PLANNING COMMISSION
DATE: 6/30/2014
AGENDA ITEM: 4B – PUBLIC HEARING
CASE # 2014-22

ITEM: Village Preserve Residential Subdivision – Preliminary Plat

SUBMITTED BY: Nick Johnson, City Planner

REVIEWED BY: Kyle Klatt, Community Development Director
Jack Griffin, City Engineer
Ann Pung-Terwedo, Washington County
Greg Malmquist, Fire Chief
Stephen Mastey, Landscape Architecture, Inc.

PRELIMINARY PLAT
 OF
 VILLAGE PRESERVE

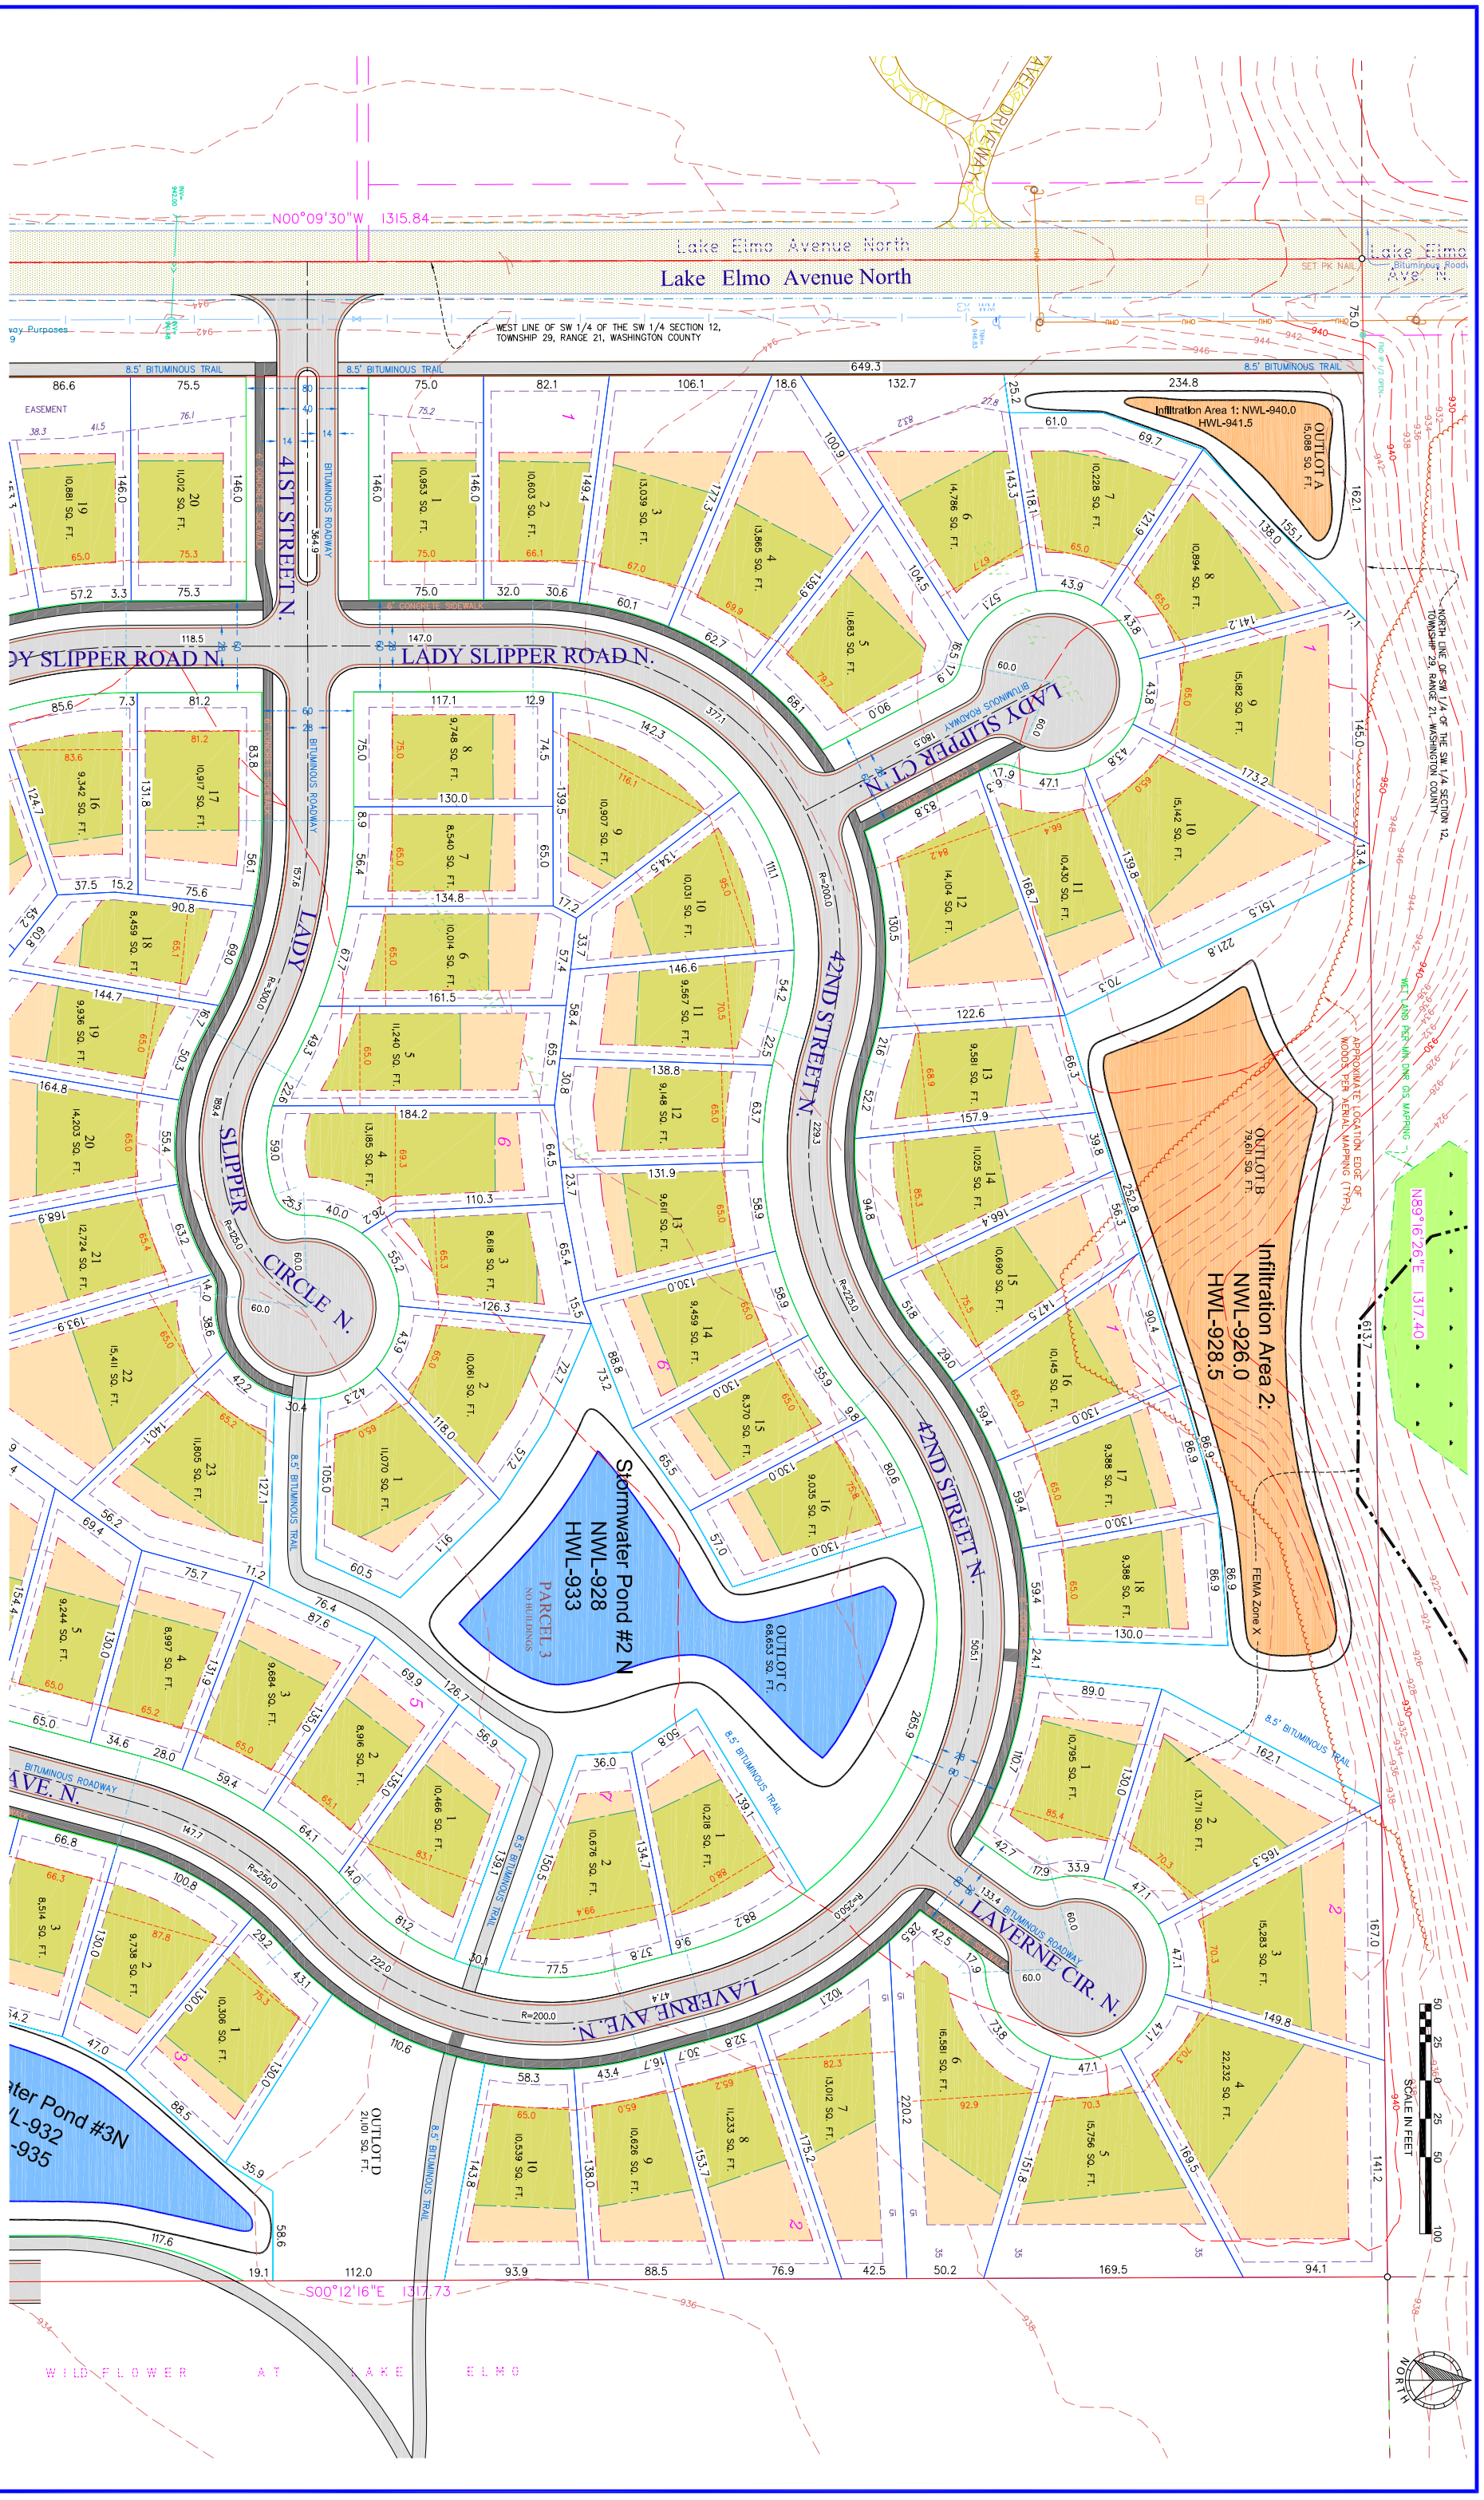
The Subdivision Ordinance requires 10% of the land in urban residential districts to be set aside as open space, which in this case amount to 3.98 acres. On the plans (PP-2), the applicant notes that Outlot D, the small neighborhood park, is 0.48 acres in size. In addition to Outlot D, the portion of Outlot C that contains the planned trail improvement would also be eligible for parkland dedication credit if the applicant constructs the trail. As this time, the applicant has not provided a calculation of the area within Outlot C that would be eligible. Staff estimates that this dedication amount is approximately 14,000 square feet (470' (length) x 30' (width of trail eligible area) = 14,100 sq. ft.). Staff would recommend that the applicant submit a detailed and updated parkland dedication calculation in advance of Final Plat. Even with the portion of Outlot C included in the calculation, it is unlikely that the total land eligible for parkland dedication as part of the Village Preserve Plat will total 3.98 acres (10%). However, as previously mentioned, the applicant hopes to dedicate +/- 15 acres of land adjacent to Reid Park. The Park Commission has expressed support for this arrangement. If accepted by the City, the applicant would be eligible to receive a land dedication credit that could be applied to other applications in the area, such as Village Preserve. Staff would recommend that the final details of the parkland dedication requirement be determined at the Final Developers Agreement. As the timing of the various subdivision applications do impact how compliance of the City's parkland dedication requirements will be achieved, staff would recommend as an option that the applicant post an escrow in the amount of the required fee in lieu of land

LANDSCAPE ARCHITECTURAL DESIGN REVIEW DATED JUNE 25TH, 2014

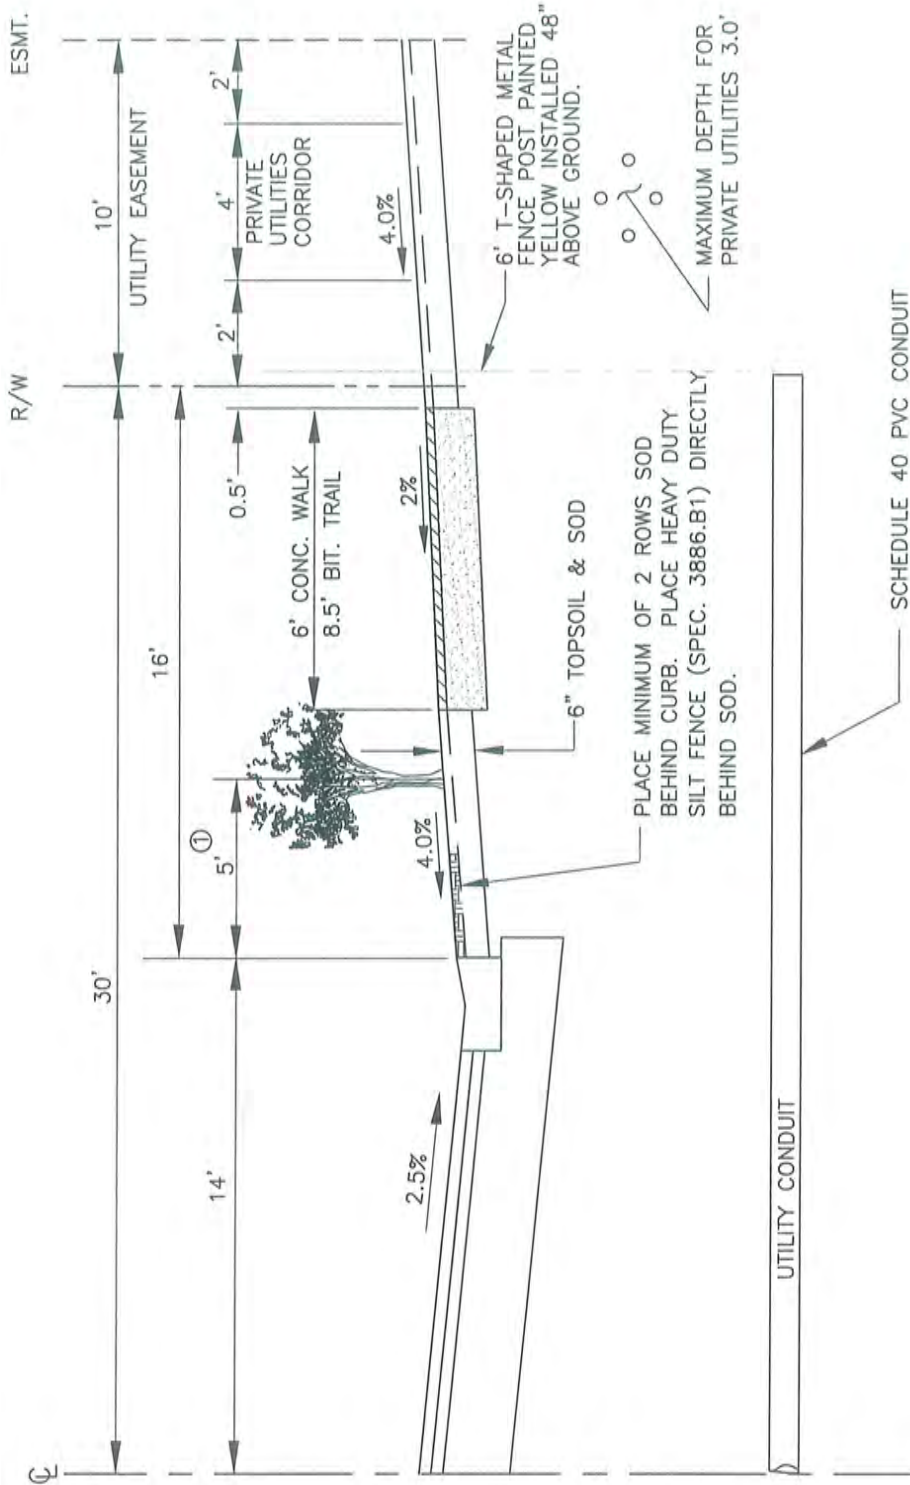
Required Action Items by Village Preserve Project Team

1. Boulevard Trees to be spaced no further than 50 feet on center.
2. See Typical Right of Way Layout – City of Lake Elmo Drawing No. 805 attached to this document for correct boulevard tree layout locations.
3. Please correct plant name spelling errors on sheet LP1.
4. Village Preserve Project Landscape Architect to provide temporary and permanent groundcover vegetation landscape plans for all lots, commonly held HOA & City R.O.W. areas.
5. Village Preserve Project Landscape Architect to provide landscape irrigation plans for all commonly held HOA & City R.O.W. areas.
